Access Compliance Report

Public Rights-of-Way

Intersection ID: 30301	Main Street: BLACK_KETTLE_DR	Cross Street: SHINKANSEN_DR	Location: W
ADA ID: 136D6E6BAEF4	Ramp Type: BlendTrans1	Initial Pass/Fail: Fail	Overall Compliance: No
		Severity Score: 12.5

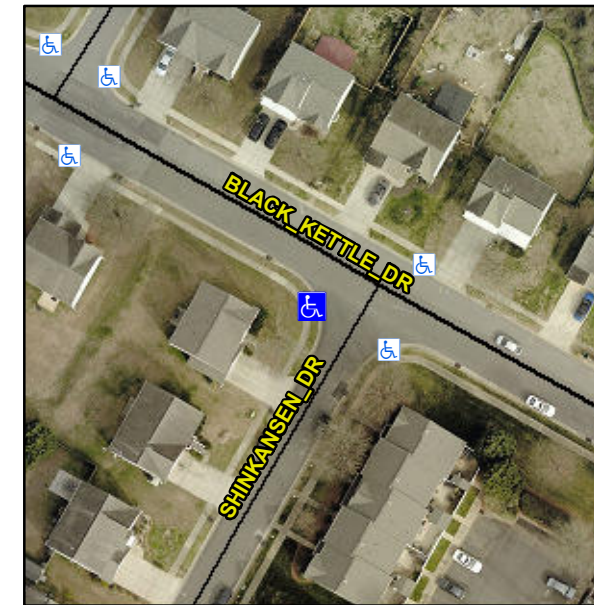
CURB LIP 0.5

Not Found, R304.5.3

Compliance	Description	Data	Compliance	Description	Data
N/A	Ramp Length (in)	48.0	Yes	BlendTrans Slope (%)	2.1
Yes	Ramp Width (in)	48.0	No	BlendTrans XSlope (%)	5.2
N/A	Flare Type LT	N/A	N/A	Flare Type RT	N/A
N/A	Flare Slope LT (%)	N/A	N/A	Flare Slope RT (%)	N/A
N/A	Flare Traversable LT?	N/A	N/A	Flare Traversable RT?	N/A
N/A	Landing Length (in)	N/A	N/A	DWS Provided?	N/A
N/A	Landing Width (in)	N/A	N/A	DWS Contrast?	N/A
N/A	Landing Slope (%)	N/A	N/A	DWS Length (in)	N/A
N/A	Landing X Slope (%)	N/A	N/A	DWS Full Width?	N/A
N/A	Landing Curb? (Y/N)	N/A	N/A	DWS Offset (in)	N/A
N/A	Shared Landing?	N/A			
N/A	Gutter Ponding?	N/A	N/A	Gutter Slope (%)	N/A
N/A	Gutter Lip Ht (in)	N/A	N/A	Gutter X Slope (%)	N/A
N/A	Painted X Walk1?	No	N/A	Painted X Walk2?	No
	X Walk 1 Direction	To SE		X Walk 2 Direction	To NE
	X Walk 1 Width (in)	N/A		X Walk 2 Width (in)	N/A
	X Walk 1 Slope (%)	6.3		X Walk 2 Slope (%)	0.5
	X Walk 1 X Slope (%)	4.5		X Walk 2 X Slope (%)	5.4

N/A	Ramp inside XWalk1?	N/A	N/A	Ramp inside XWalk2?	N/A
	Road Slope (%)	6.9		Clear Space?	N/A
	Road X Slope (%)	1.7	N/A	Clear Space to XWalk (in)	N/A
N/A	Any Obstructions?	N/A	N/A	Storm Grate/Utility Hazard?	N/A
	Obstruction Type			Storm Grate/Utility Type	
		N/A			N/A
			Yes	Surface Condition? (G/P)	Good
			No	Curb Slope (%)	5.5

Remove & Replace Curb Ramp With Two New Directional Ramps or Equivalent.
